SAFETY EVALUATION BY THE OFFICE OF NEW REACTORS
RELATED TO AMENDMENT NO. 2 TO THE COMBINED LICENSE NO. NPF-91
AND LICENSE NO. NPF-92
SOUTHERN NUCLEAR OPERATING COMPANY, INC
GEORGIA POWER COMPANY
OGLETHORPE POWER COMPANY
MUNICIPAL ELECTRIC AUTHORITY OF GEORGIA
CITY OF DALTON, GEORGIA
VOGTLE ELECTRIC GENERATING PLANT UNITS 3 AND 4
DOCKET NOS.: 52-025 AND 52-026

3.1 Nuclear Island Basemat Evaluation

3.2 Nuclear Island Foundation Stability Evaluation

Figure 1 Elevations at Subgrade and Top of the Mudmat, VEGP Unit 3

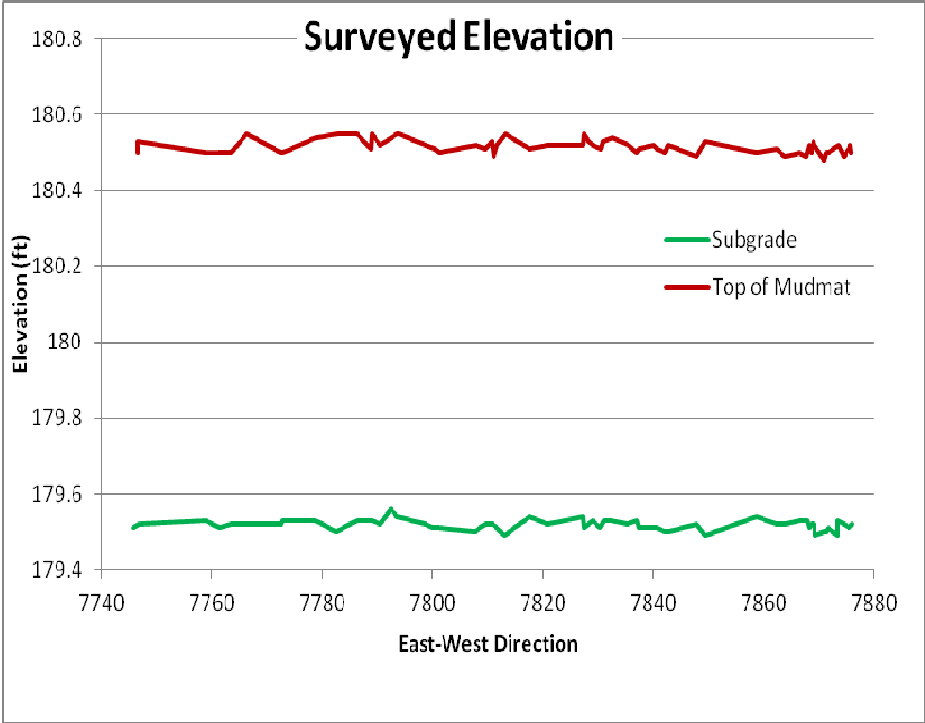
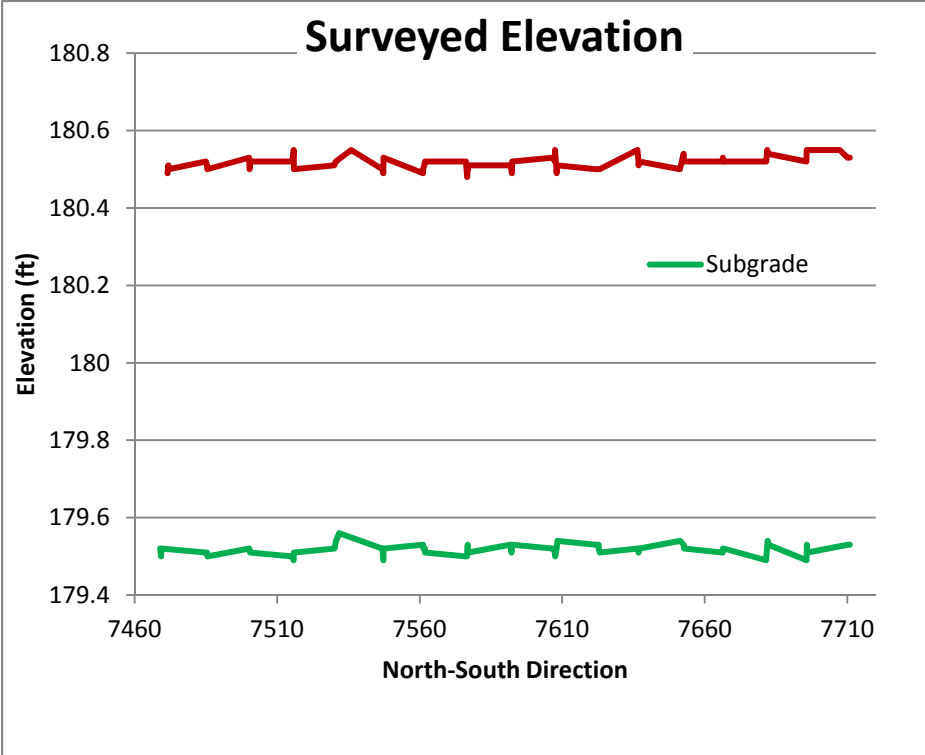
The staff examined the survey data and generated some plots to visualize the data (Figure 1 to Figure 3). Based on the information provided, the staff observed that:

1. The survey elevations at surface of subgrade (the top of backfill soil) randomly vary about 0.84 inches ranging from EL 179.49 to 179.56 ft;
2. The surveyed elevations at the surface of the mudmat randomly vary about 0.84 inches, and survey elevations range from EL 180.48 to 180.55 ft;
3. The thickness of the mudmat randomly varies from 11.5 to 12.7 inches;
4. The mean settlement is about 1.0 inch and varies from 0.71 to 1.5 inches among the settlement markers from July 21, 2011 to July 2, 2012;
5. The mean settlement is about 0.012 inches and varies from -0.024 to +0.096 inches among the settlement markers from March 7, 2012 to July 2, 2012.

1. The variation of elevations at the subgrade surface and at the mudmat surface resulted from the construction process and did not show any abnormality;

2. The variation of thickness of the mudmat is within the design allowance (plus or minus three-fourths of an inch tolerance);
3. The observed settlement from July 21, 2011, to July 2, 2012, after placement of the mudmat, is more than the model predicted, about 1 inch versus 0.2 inches. The observed settlement apparently included the settlement caused by the weight of the mudmat, the continued consolidation of over 40 ft of backfill soil, and other factors, such as the modeled settlement mark elevations of July 21, 2011;

Figure 3 Foundation Settlement from March 7, 2012 to July 2, 2012 at Nuclear Island, VEGP Unit 3

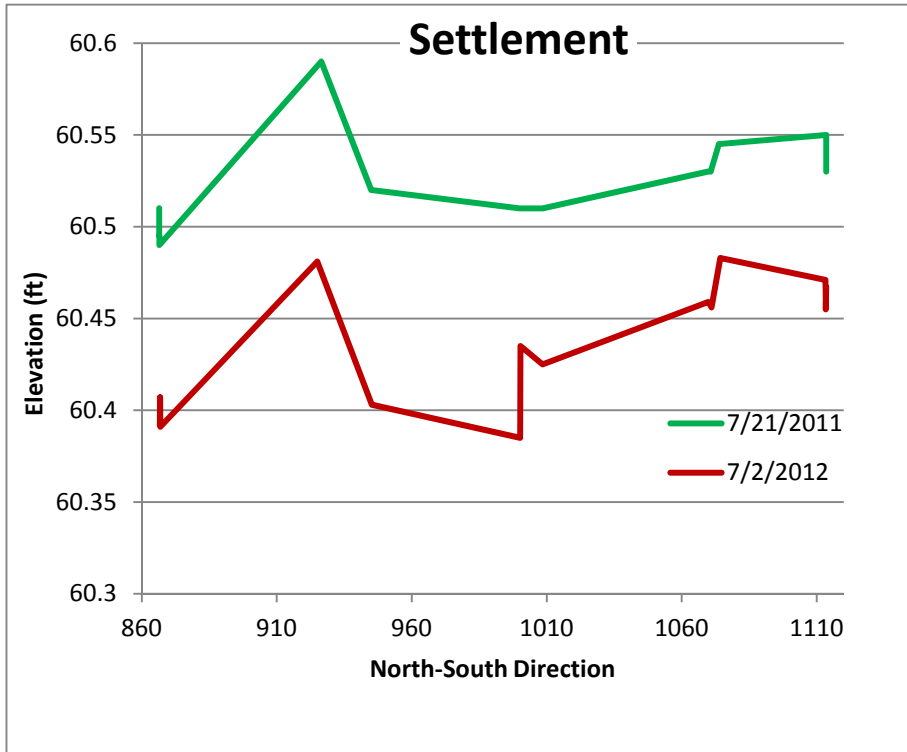
4. The measured settlements from March 7, 2012, to July 2, 2012, vary from -0.024 to +0.096 inches. This observation shows that the settlement is minimal, or even within the data accuracy because of the negative settlement obtained, during this period of time and it indicates that the subgrade soil is stabilized;

2. The measured foundation settlements after the placement of the mudmat varied from -0.024 to +0.096 inches during the period from March 7, 2012, to July 2, 2012. This minimal foundation settlement indicates that the subgrade soil has been stabilized.
